PORTA FRAME E BOISERIE

CI - 29/MAIO/26

PORTAS GLASS FRAME E GLASS BOISERIE

FRAME AND BOISERIE DOORS

FRAME

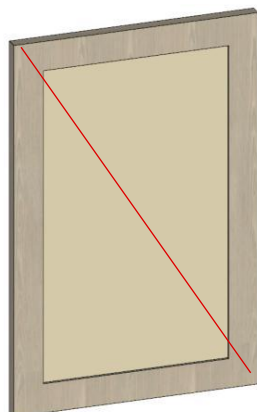
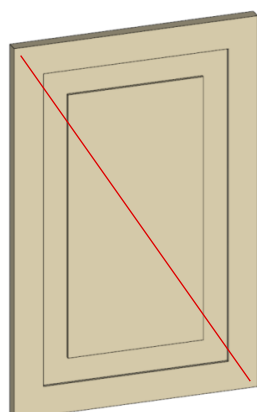
Informamos que as portas Frame e Boiserie passarão por mudanças em sua estrutura, que era usinada e passa a ser com molduras. Desse modo, será mantida o acabamento em lâmina de madeira apenas no painel central, não sendo mais utilizada na moldura desses modelos. Além disso, comunicamos que o modelo Frame não poderá mais ser fabricado com almofada.

PORTA GLASS FRAME

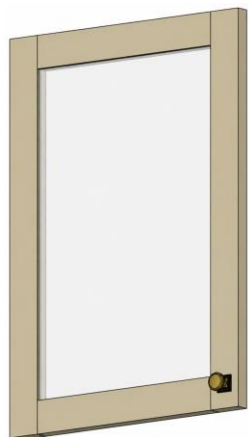
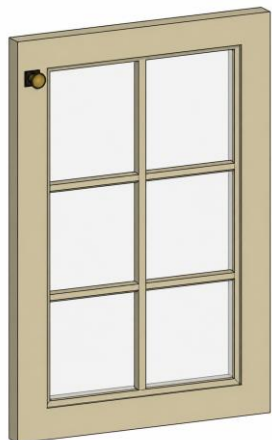
Comunicamos uma alteração importante nos modelos de portas Glass Frame e Glass Boiserie. A partir de agora, essas duas versões deixarão de ser fabricadas com a configuração em coluna, tendo altura máxima de 1560mm correspondente ao módulo cristaleira.

FRAME

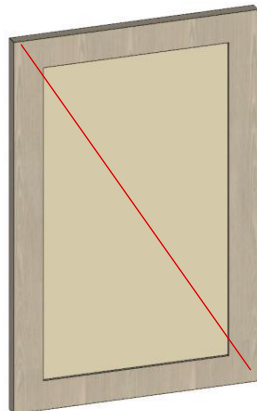
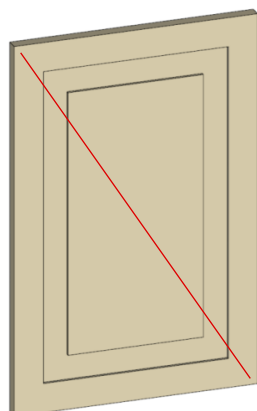
We inform you that the Frame and Boiserie doors will undergo changes in their structure, which now has frames. In this way, the wood veneer finish will be maintained only on the central panel, no longer being used in the frame of these models. In addition, we communicate that the Frame model can no longer be manufactured with a “cushion”.

GLASS FRAME DOOR

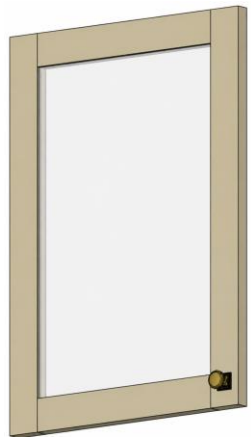
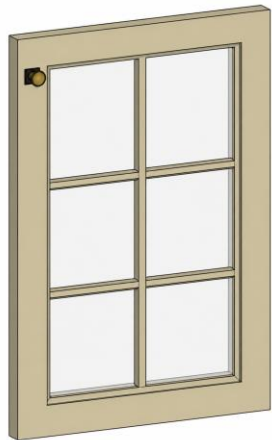
We announce an important change in the Glass Frame and Glass Boiserie door models. From now on, these two versions will no longer be manufactured with the column configuration, with a maximum height of 1560mm.
